HISTORIC PRESERVATION BOARD

AGENDA

HISTORIC PRESERVATION BOARD MEETING

STAFF MEMORANDUM
HISTORIC PRESERVATION PROGRAM
PLANNING AND URBAN DEVELOPMENT

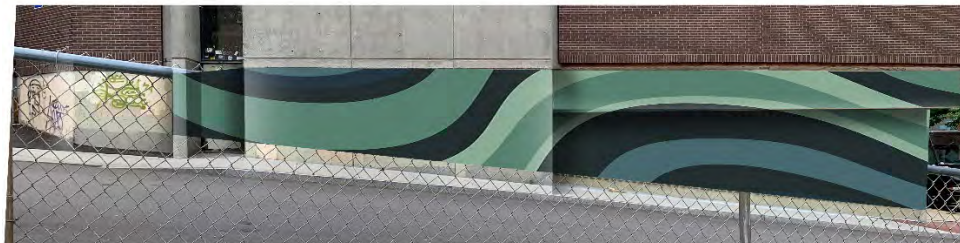
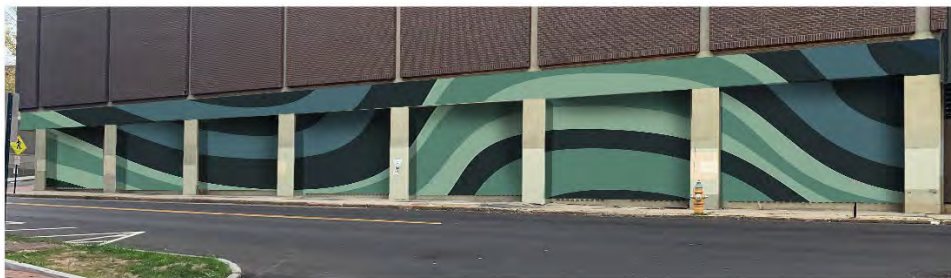
At the preliminary workshop the board expressed concerns over the following:

- That the vivid colors were too bright and would be distracting and detract from the adjacent historic structure
- That the desired look would not be achievable given the highly textured concrete surface
- That the proposed mural design did not engage with the designed architectural character of the building base

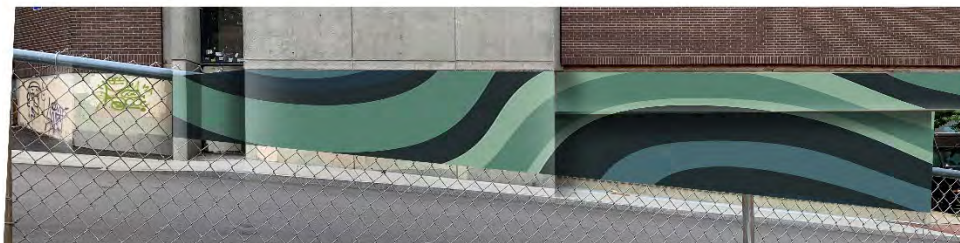
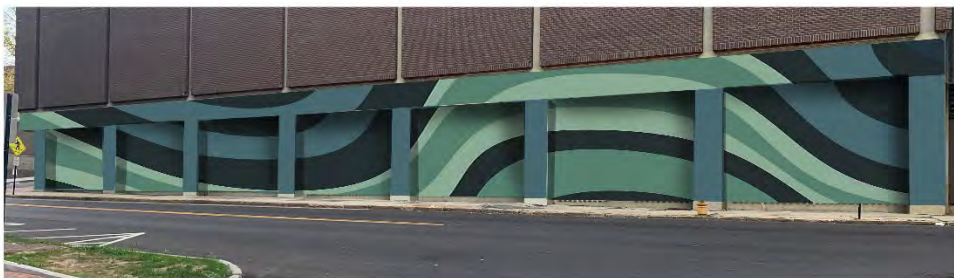
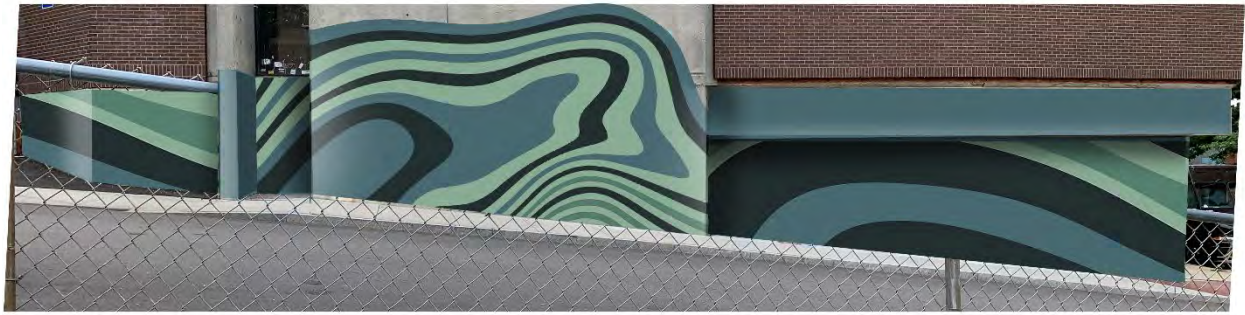
A preliminary revised design with more muted waves of color was presented, which prompted questions about the extent of the mural on the Oak Street frontage, and how the design would engage with the architecture:

- Design needs to acknowledge the bay pattern and treat the piers and lintels so the structure is visually expressed.
- Continue up Oak Street to prevent tagging on unpainted surfaces.

FINAL SUBMISSION – AUGUST 3, 2022 PUBLIC HEARING

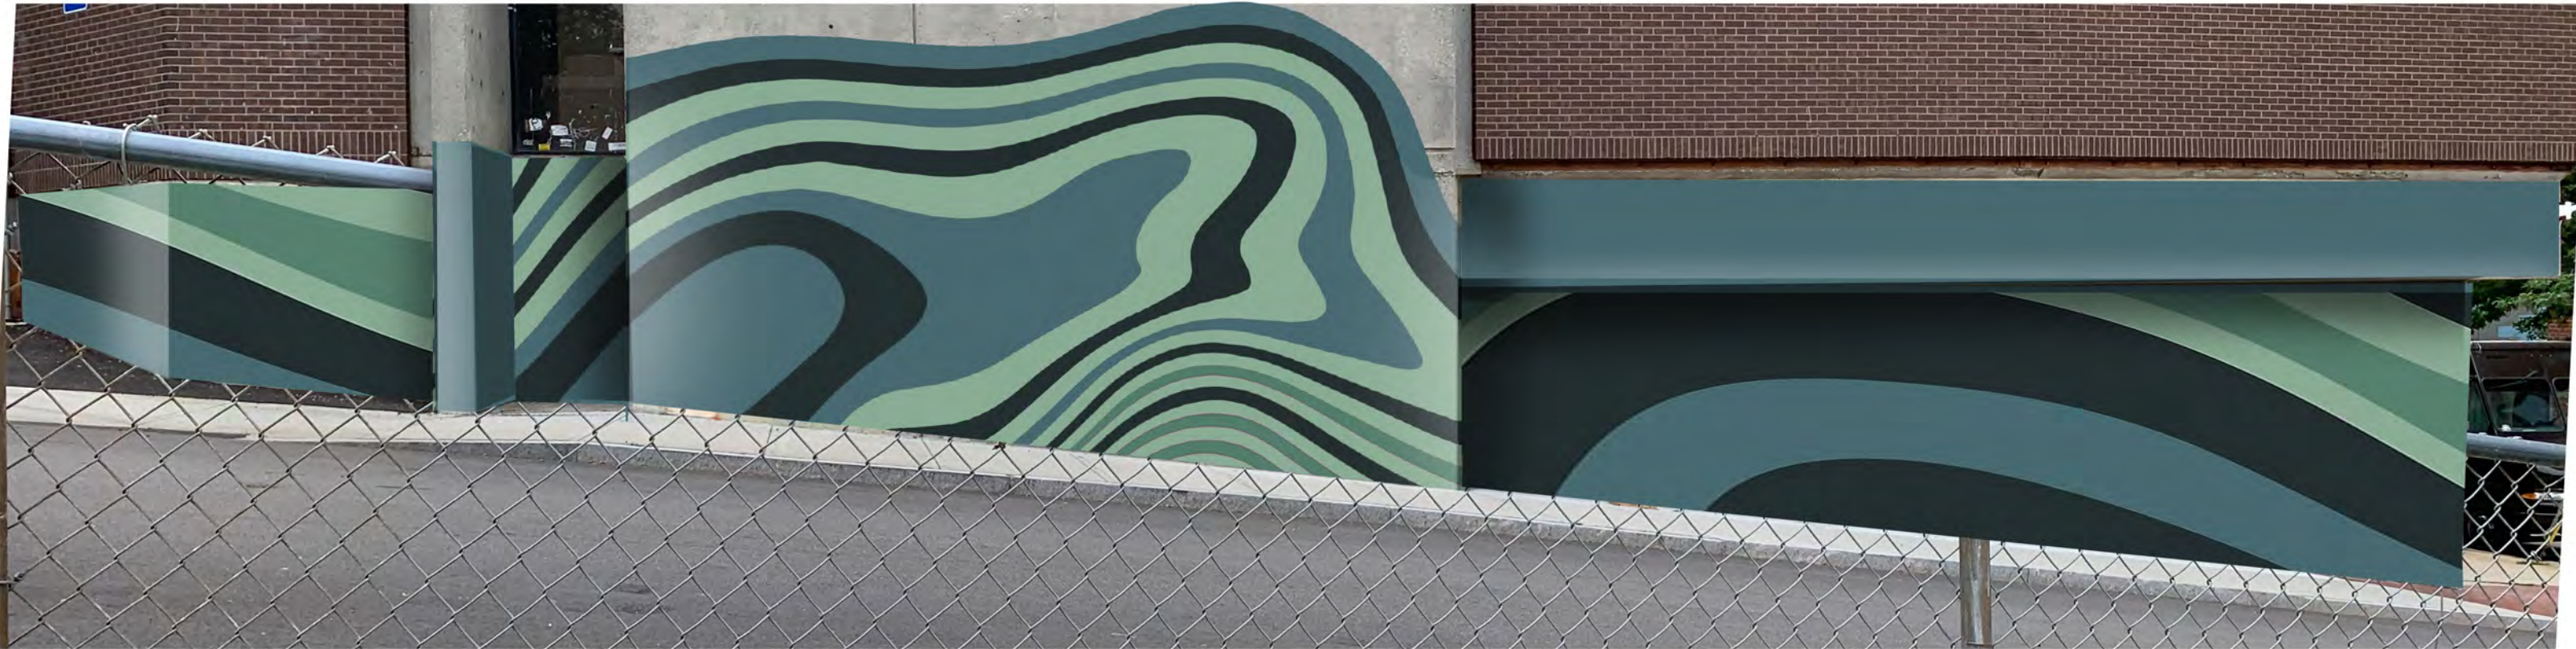
Although 404 Cumberland Avenue is classified as a noncontributing addition to 55 Forest Avenue, the applicable Standard for Review of Alterations to Noncontributing Structures reads:

“The intent of the review shall be to ensure no further erosion of any existing architectural character of the subject structure determined to be significant by the Planning Authority or Historic Preservation Board...”

Further, both Board members and staff have asserted that murals should show a degree of sensitivity to the context and should not be unduly visually distracting. As it is adjacent to the landmark Art Deco building at 55 Forest Avenue, this position is particularly relevant.

Standard A.	
In considering an application for a Certificate of Appropriateness involving alteration(s) to a noncontributing structure the standards for review of alterations set forth in Subsection 17.8.2 shall apply as applicable. The intent of the review shall be to ensure no further erosion of any existing architectural character of the subject structure determined to be significant by the Planning Authority or Historic Preservation Board and, where practicable, to guide projects toward a more compatible relationship with the surrounding context.	
Standard Met?	Staff Comments
Yes	Mural design has evolved in response to Board comments, to engage with the architecture of the building and prevent an unduly distracting mural.

I move to CONDITIONALLY APPROVE application HPBR-001881-2021 for MURAL INSTALLATION at 404 CUMBERLAND AVENUE on the basis of documentation, plans, and specifications submitted for the 8/3/22 public hearing; information provided in the staff memo; and findings by the Historic Preservation Board that the project meets Standards for Review of Alterations 17.8.2- #7, 9, and 10; Standards for Review of Alterations to or Redesign of Noncontributing Structures 17.8.4-# A, subject to the following conditions:

- 1) Staff to review with applicant and artist final installation details and agreements between applicants, owners, and artist regarding maintenance and paint color specifications.

A2-00	EXTERIOR ELEVATIONS: SOUTH	ISSUED FOR HP BOARD APPROVAL NOT FOR CONSTRUCTION	JULY 22, 2022	STUDIO E P. O. BOX 1385 WESTBROOK, ME 04098 860-874-1033
	CARMONA BARN

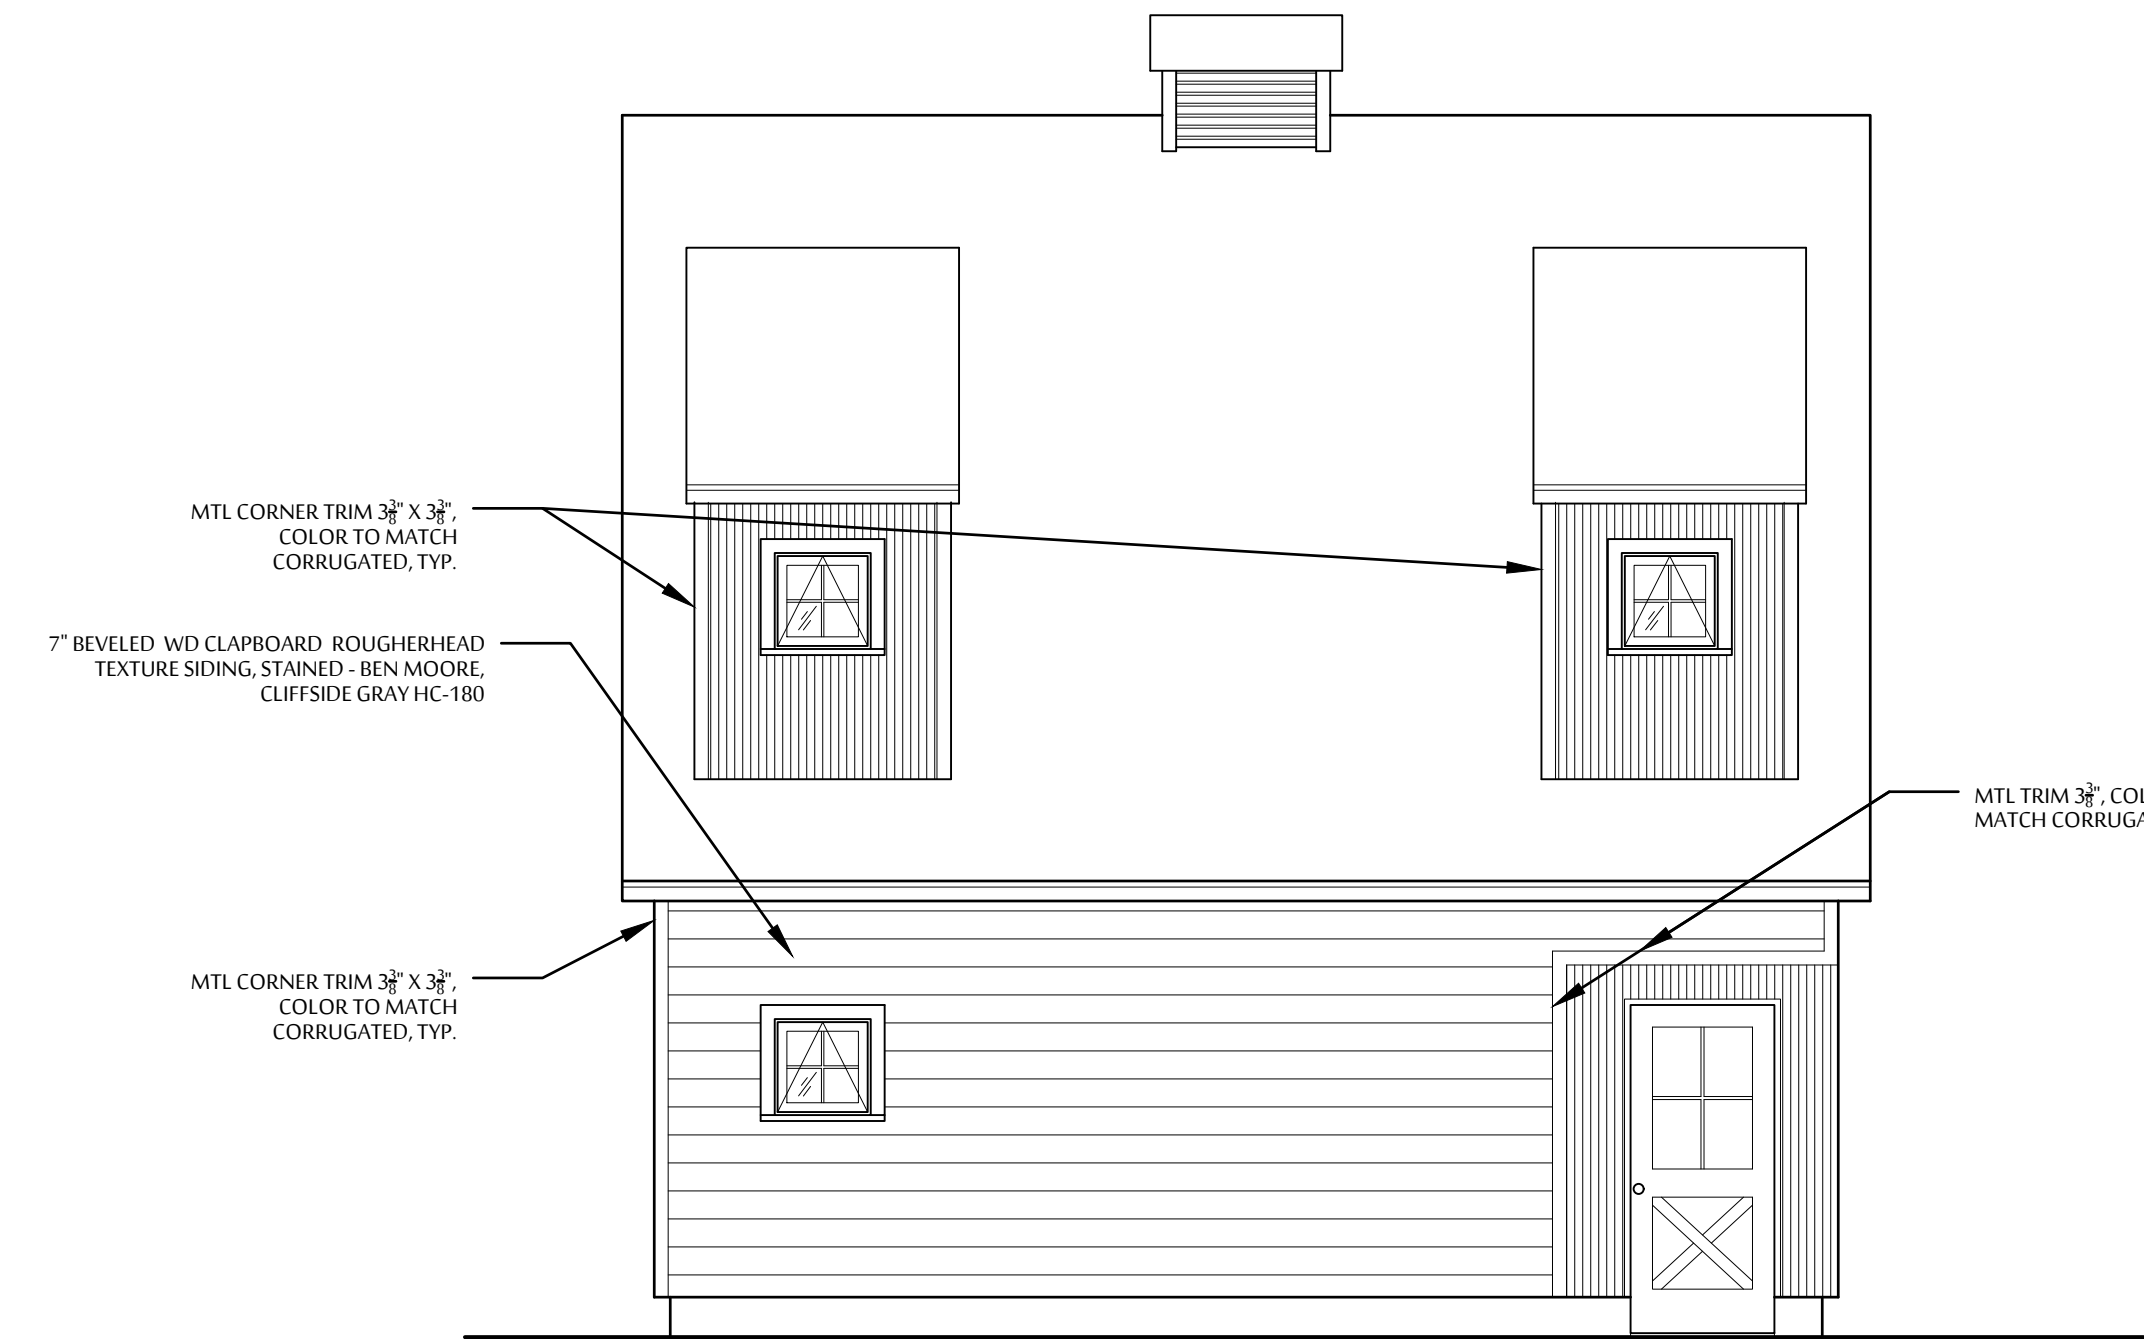
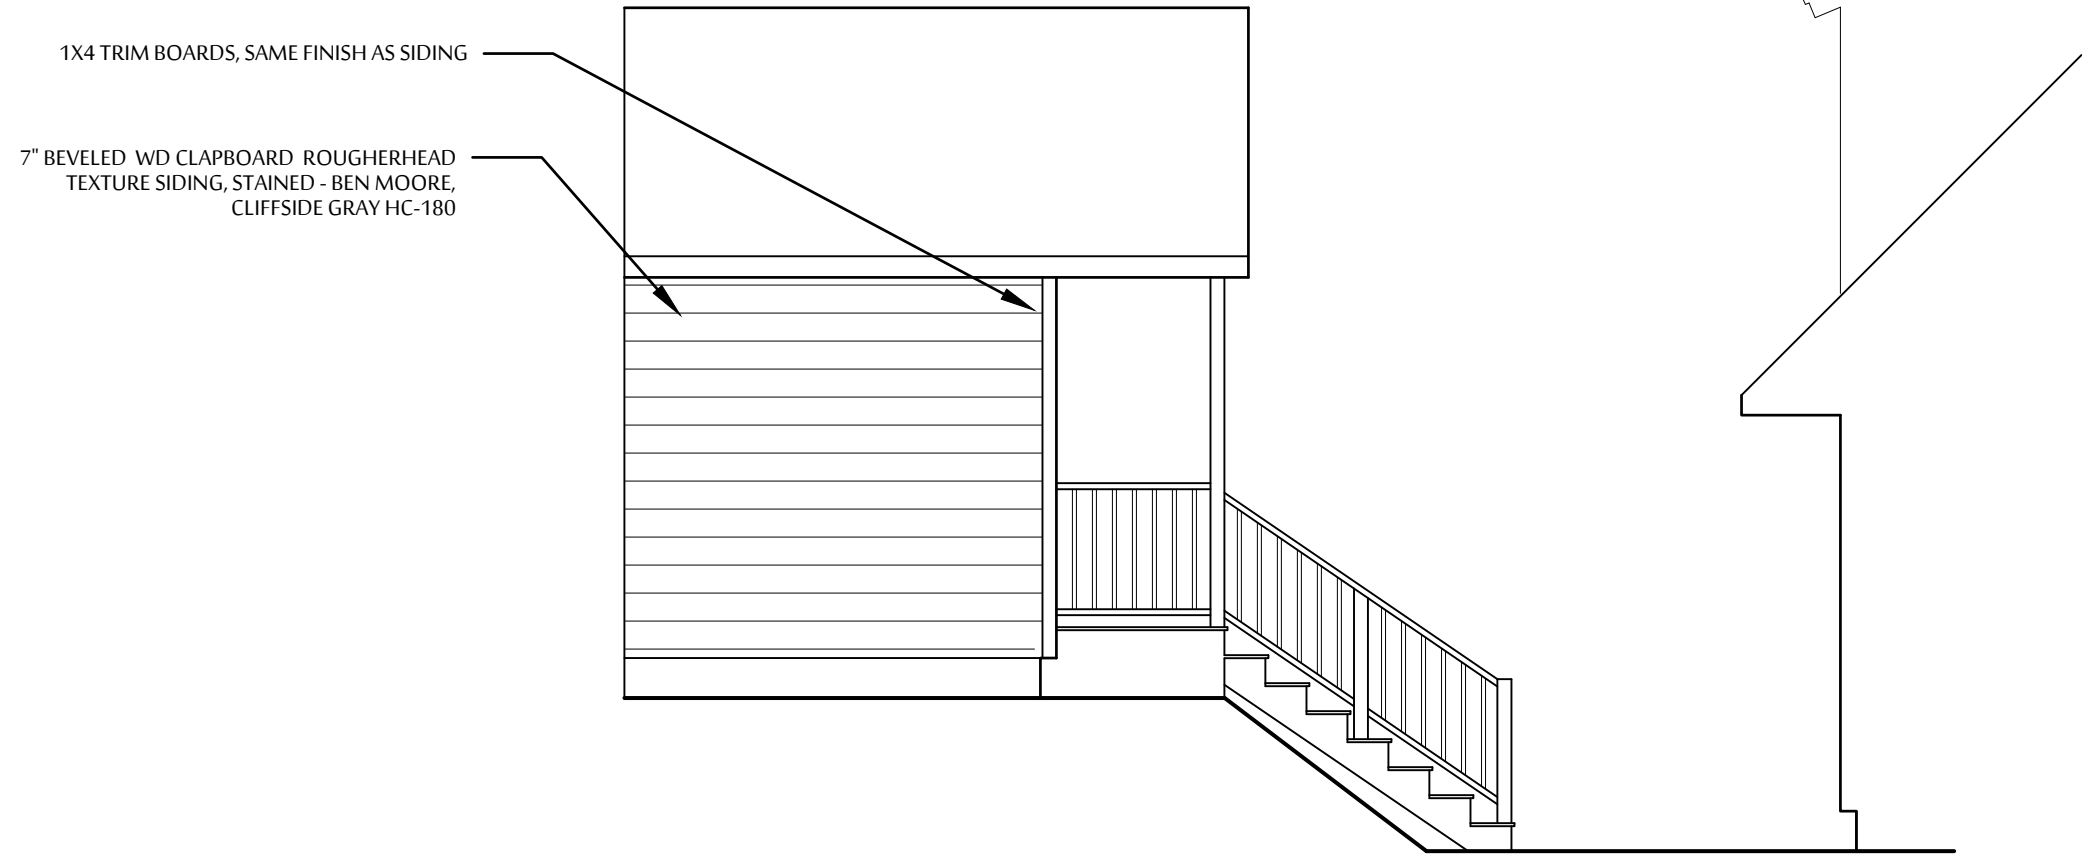
- Lowering the eaves and overall height improves the relationship to the primary house.
- One result of the lowered eaves is that the gable is quite wide, and in fact is wider than the gable on the front of the house. Though staff would not consider a change to be essential, it may be worth considering raising the eaves just slightly, to narrow the gable.

- Staff questions the intrusion of the metal siding onto the front elevation. Though they may be intended to add visual interest and foster connection between materials on adjoining faces, the asymmetrical corner panels on the lower front walls add a confusing element to the primary façade.
